**TOWN OF BROOKLYN
PLANNING AND ZONING COMMISSION
Regular Meeting Agenda
Tuesday, September 21, 2021 6:30 p.m.**

- a. **Reading of Legal Notice: None.**
 - b. **New Public Hearings:**
 - 1. **SP 21-002:** Special Permit Application for Multi-Family Development (51 Condominium units) on south side of Louise Berry Drive (Assessor's Map 33, Lot 19), 13.5 acres, R-30 Zone, Applicant: Shane Pollack.

Page 224 Plan set titled "Proposed Multifamily Condominium Development" prepared by Killingly Engineering Associates, 11 sheets, revised 4-20-2021

Page 264 Peer Review of Site Plan and Special Permit Objectives prepare by LADA, dated 9-13-2021

ROOF LEADER PIPE IN TRENCH DETAIL

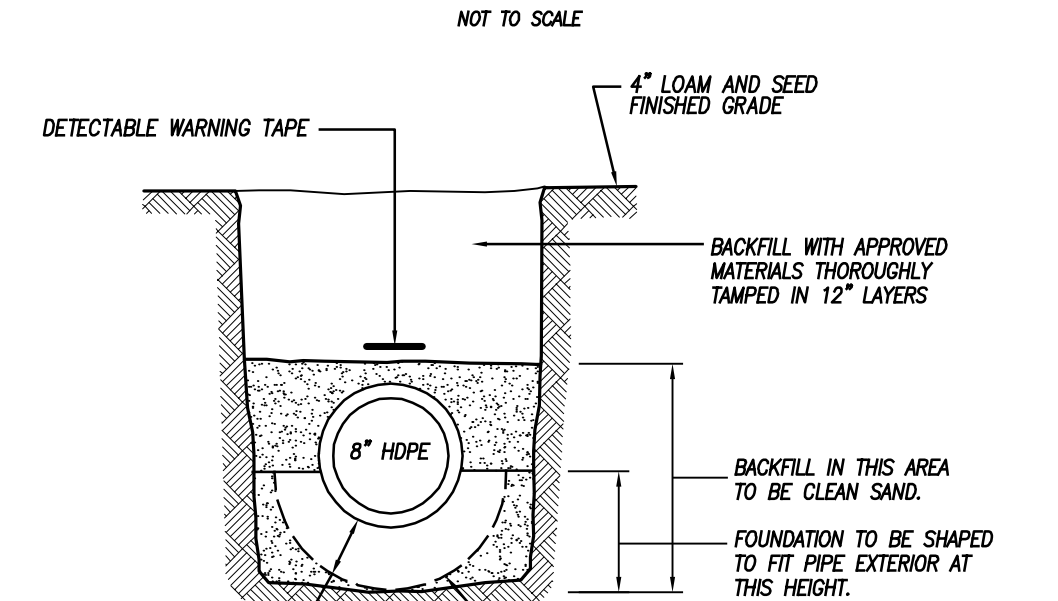
The “red” comment has been addressed, **however, the “Roof Leader Pipe in Trench Detail” on Sheet 7 of 9 needs to be revised to show the correct size of the pipe, which is 8” NOT 6”.**

HOODED CATCH BASIN DETAIL
NOT TO SCALE

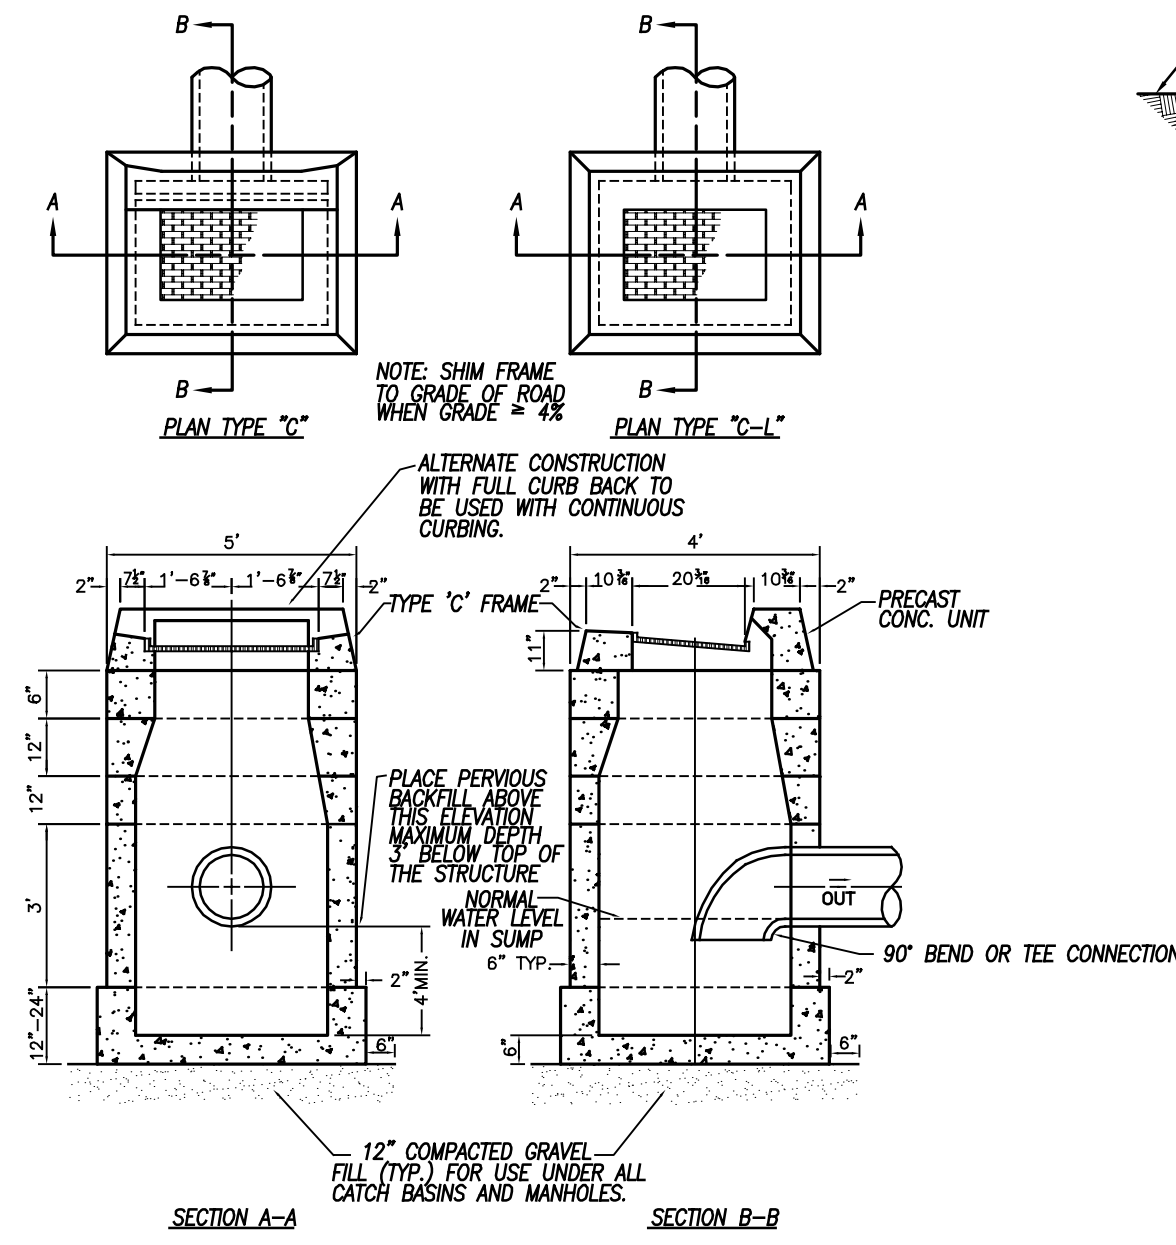
As stated by KEA, the catch basin detail on this plan has been modified to show a 4'-0” sump. However, the elevations of the catch basin on the new Road Profile plan (Sheet 6 of 9) reflect elevations of catch basins with 2'-0” sumps. This needs to be corrected.

TURF REINFORCEMENT MAT INSTALLATION
NOT TO SCALE

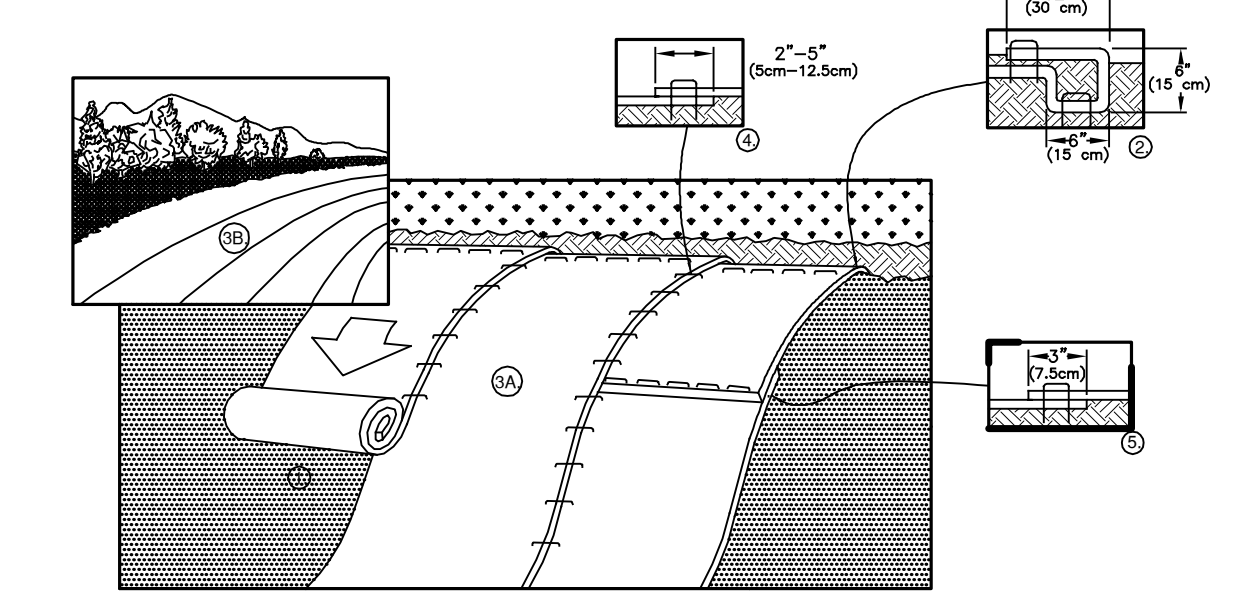
The “red” comment has not been addressed in the “Turf Reinforcement Mat Installation” detail on Sheet 7 of 9. This detail should be removed in its entirety because there is another “Turf Reinforcement Mat Installation” detail on Sheet 8 of 9 that specifies a biodegradable product, North American Green SC-150BN.

TEMPORARY SEDIMENT TRAP EMBANKMENT CROSS SECTION
NOT TO SCALE

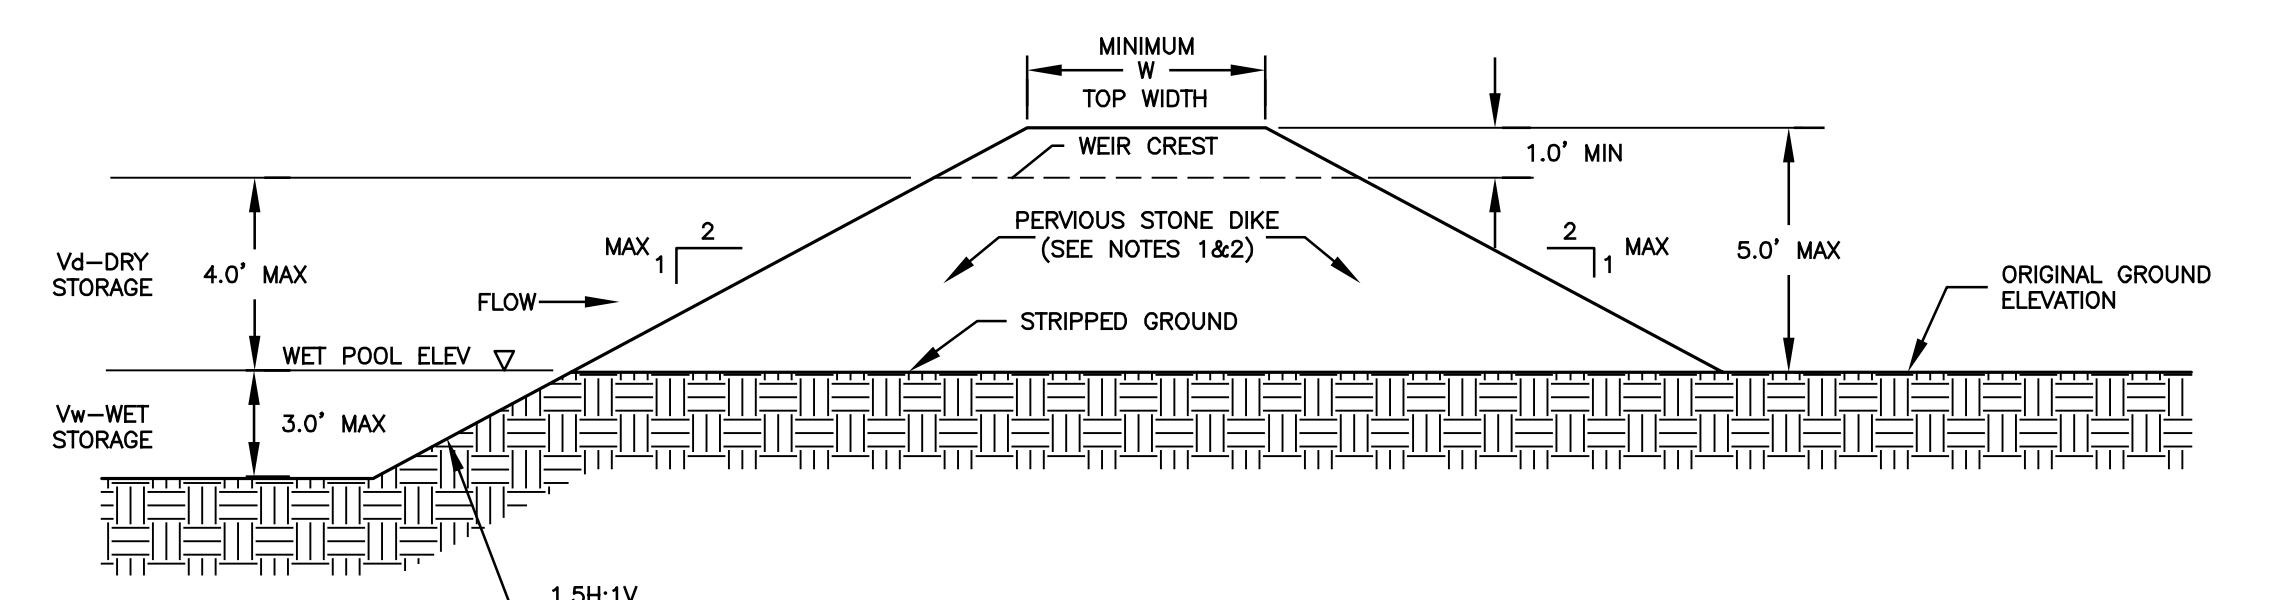
23. As shown on the plan, the temporary sedimentation basin will be constructed in an area where there is a six (6) foot difference in elevation across its width (west to east). According to the “Temporary Sediment Trap Embankment Cross Section” located on Sheet 7 of 8, a 3’ (max.) deep level bottom excavation, starting on the west side of the basin will require about an 8’ deep excavation on the east side of the basin. If this is not the way the basin is to be constructed and instead will be a combination of berm construction on the low (west side) and 3’ deep excavation on the east side, that should be shown in the detail on Sheet 7 of 8. In any case, no deep test holes have been dug here to show where groundwater may lie or where an average seasonal high water table may exist, which would be evidenced by soil mottles, to see if there would be an impact on the basin. Constructing the basin with a earthen berm should be shown on the plans because of the large area of tree removal that will occur. How would accumulated water be managed for this basin? What would be the likelihood of an embankment failure if not built with an emergency spillway protected with at least riprap armoring? Furthermore, there is no sediment control system (silt fence or hay bales) surrounding the proposed temporary sedimentation basin, because any sediment laden water that rises to the point where it would flow through the stone dike, the dike will not necessarily trap fine particles of sediment with much efficiency. Also, the aforementioned sediment trap detail incorporates a weir of unknown length at the crest of the stone dike. An explanation of how the weir will function, knowing the pervious stone dike will allow the passage of water, is needed. Drainage calculations are also needed.

TYPICAL SECTION-UNREINFORCED RETAINING WALL
VERSA-LOK OR APPROVED EQUAL

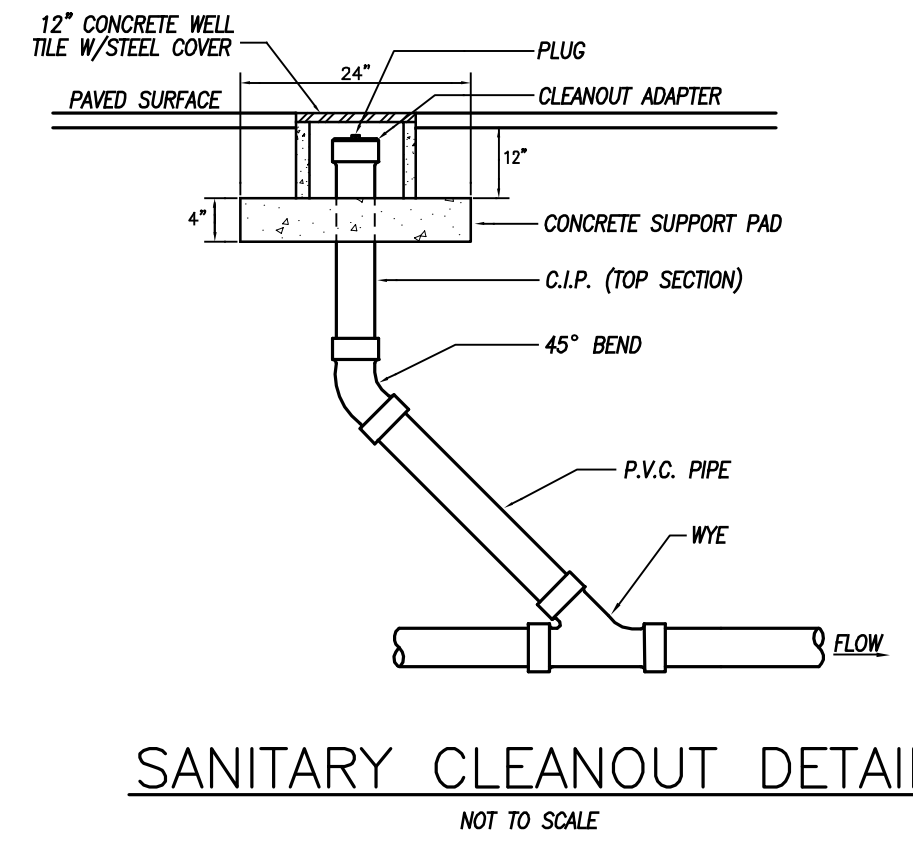
6. In front of Units 1-3, the plan shows that a "block retaining wall" is to be constructed opposite the units. Is this to be the Versa-Lok unreinforced retaining wall depicted on Sheet 8 of 8? If so, it should be labeled as such. Also, how are vehicles going to be prevented from driving over the top of the wall because there is no railing or fence shown to be installed to prevent this?

SEWER CONNECTION DETAIL
NOT TO SCALE

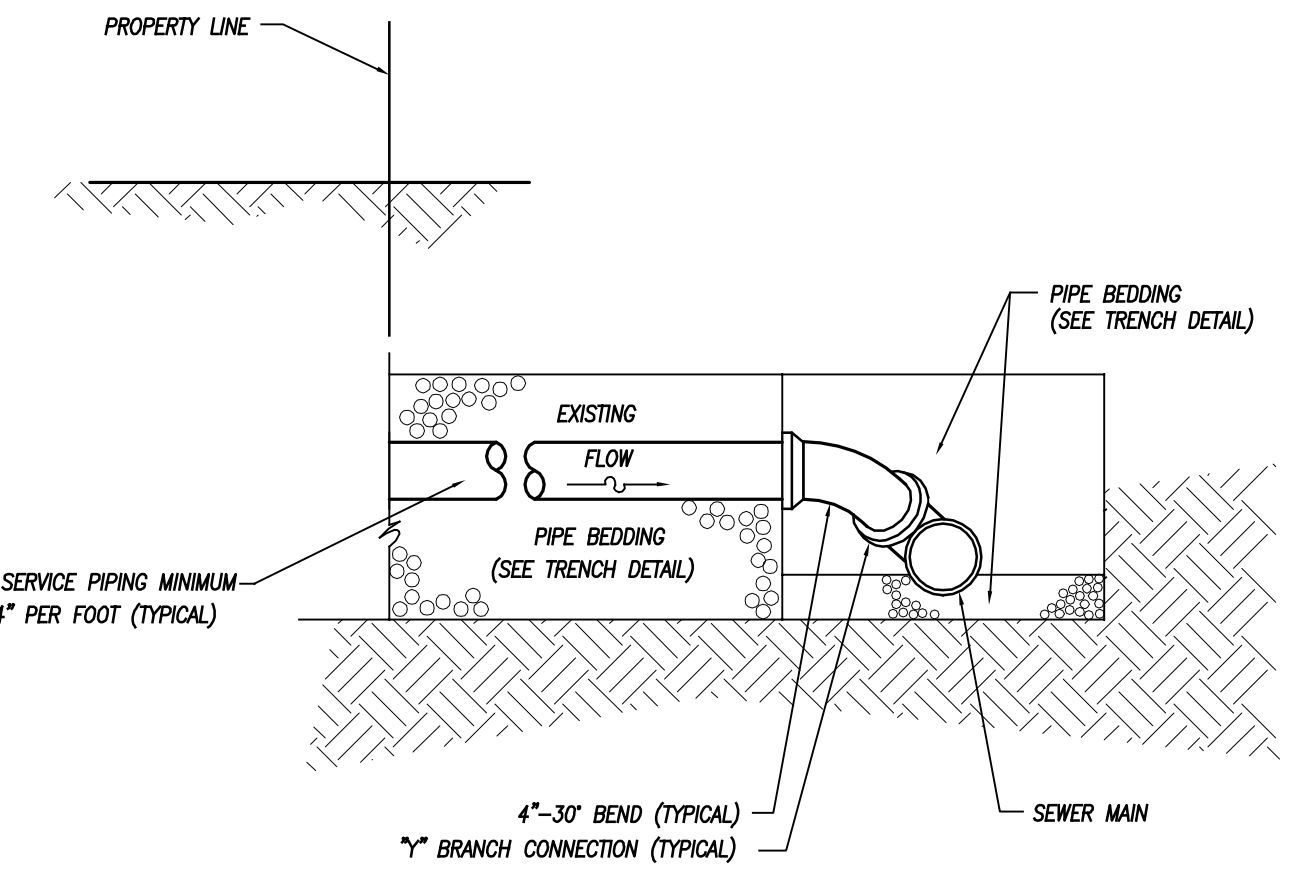
On plan Sheet 5 of 9, KEA has added an additional sanitary sewer manhole (S1) at STA 8+22.87 (8.12’ LT). However, if the connection of each housing unit (Nos. 1 – 3) to the sewer main is to be as depicted in the “Sewer Connection Detail” shown on Detail Sheet 3 (Sheet 9 of 9), then the sewer main needs to be extended further up the road and an additional sewer manhole constructed at STA 9+35, more or less.
